# RECORD OF DECISION

2350 Fifth Ave., New York (AKA, PS 141)  
State Superfund Project  
New York, New York County  
Site No. 231004  
March 2011

Prepared by  
Division of Environmental Remediation  
New York State Department of Environmental Conservation

FIGURE  
**6**

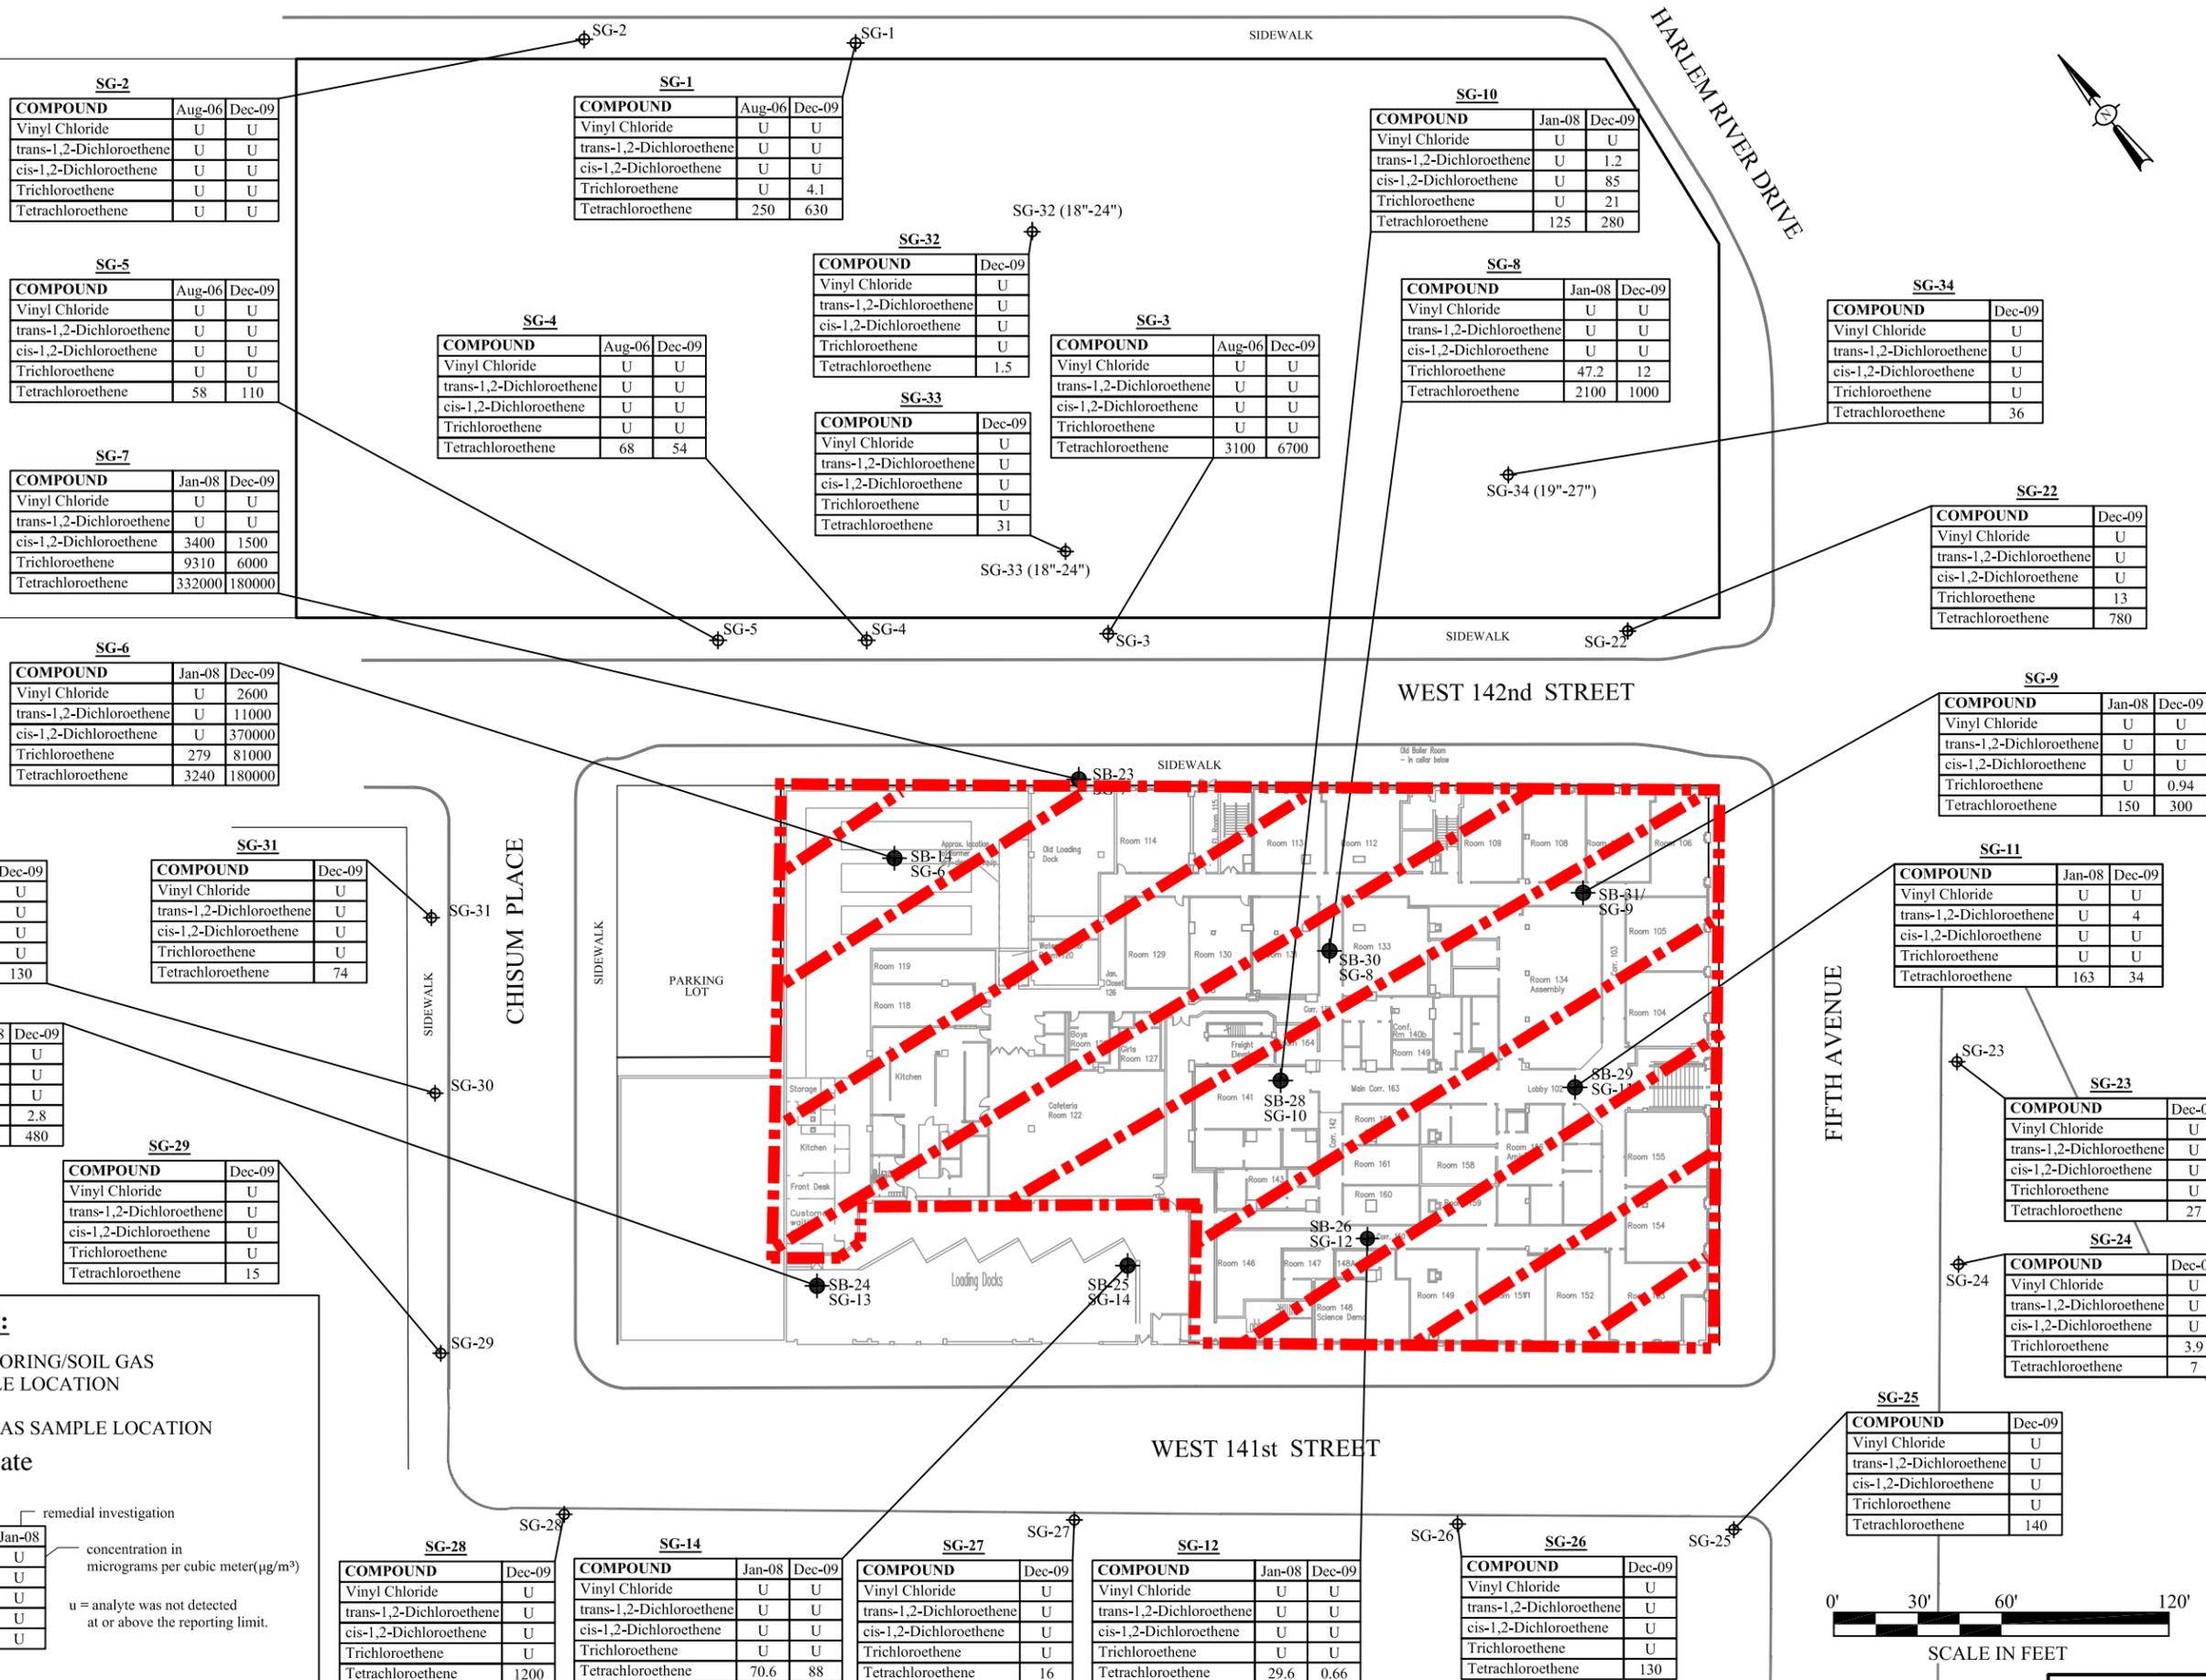
**COMMENT 14:** *There has been no indoor air or sub-slab sampling at the residential buildings (Delano Village) immediately to the south of the site, despite significantly elevated levels of PCE in soil gas at the south-sidewalk monitoring points. In particular, the soil-gas well at the corner of Chisum and 141<sup>st</sup> St. showed PCE at 1200 µg/m<sup>3</sup>. This high soil-gas reading does not necessarily demonstrate that there are high levels of PCE indoors, but it clearly calls for indoor air and sub-slab sampling. If soil-gas levels under any of the nearby buildings approach the 1200 µg/m<sup>3</sup> level, New York's current Vapor Intrusion Matrix 2... would require mitigation. Furthermore, there are no groundwater monitoring wells at that corner that might be used to delineate the edge of the site's groundwater plume.*

**COMMENT 19:** *However, high concentration of vapor was detected outside the building under the sidewalk of West 142<sup>nd</sup> Street with 332,000 ug/m<sup>3</sup> (ppb) Tetrachloroethylene in SG-7 indicating the Vapor Intrusion is leaving the site in a northerly direction. This is [sic] above the [sic] solubility limit for Tetrachloroethylene so undoubtedly there is DNAPL present that should be investigated. These concentrations of solvent are typical of soils with an insoluble separate phase of pure solvent (DNAPL) still in the formation. This suspected DNAPL may not follow the groundwater flow and appears to be headed north towards the Armory foundations.*

**RESPONSE 14:** The referenced soil vapor concentration of 1200 µg/m<sup>3</sup> was detected at SG-28, a sampling point which is located the farthest from the identified source of contamination. There are also soil vapor sample locations with lower concentration of PCE located between the source area and the SG-28 sampling location. It is not believed that this anomalous soil vapor concentration at SG-28 is related to the site contamination because it is located hydraulically upgradient from the source, and may be related to an unknown upgradient source. However, during the remedial design phase, the Department will require the collection of additional soil vapor samples in the vicinity of SG-28 to better define the source of the elevated levels of PCE at this location. Following review of the results of the additional soil vapor sampling, NYSDOH will determine whether sub-slab and indoor air sampling is needed in the residential buildings.

**RESPONSE 19:** Soil vapor concentrations at location SG-7 were recorded at 332,000 ug/m<sup>3</sup> in January 2008, and at 180,000 ug/m<sup>3</sup> in December 2009. (It should be noted that the concentration ug/m<sup>3</sup> does not have a direct correlation to parts per billion, or ppb, as it is stated by the commenter.) Groundwater and soil samples collected from the immediate vicinity of SG-7 identified low to moderate concentrations of contaminants (maximum concentration in soil is 79 ppb, maximum concentration in groundwater is 90 ppb). These concentrations do not approach the solubility limit (which applies to groundwater, but not to soil vapor). None of the more than 150 soil and groundwater samples collected during the various phases of investigation have identified concentrations which suggest a source of mobile DNAPL exists at the site.
